Town of Wakefield
Greenwood Square/Greenwood School Area
September 2013

MAKING MASSACHUSETTS MORE WALKABLE

Purpose

Planters along the Greenwood Plaza parking lot define and enhance the pedestrian zone along Main Street.

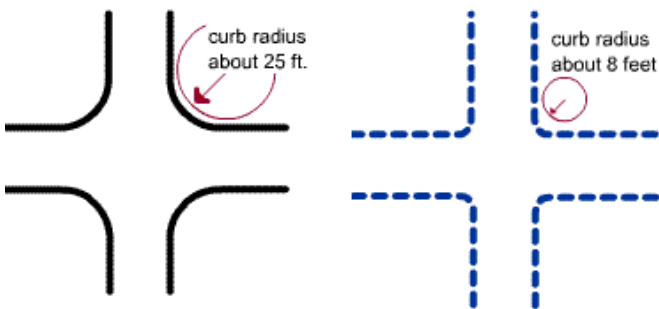
4. Observation: The planned expansion on the north side of Greenwood Plaza would benefit from plantings and/or an outdoor seating area to draw customers into the retail establishments.

As development expands in Greenwood Plaza, business owners should consider reserving space for outdoor plantings to define parking and pedestrian areas. An outdoor seating area would add life to the area and possible bring the focus to people rather than parking cars to this area.

- Consider reducing the parking count and adding a defined outdoor seating area or parklet along this stretch of Main Street
- Install planters to separate the parking lot from the street edge that add color and softness to this area
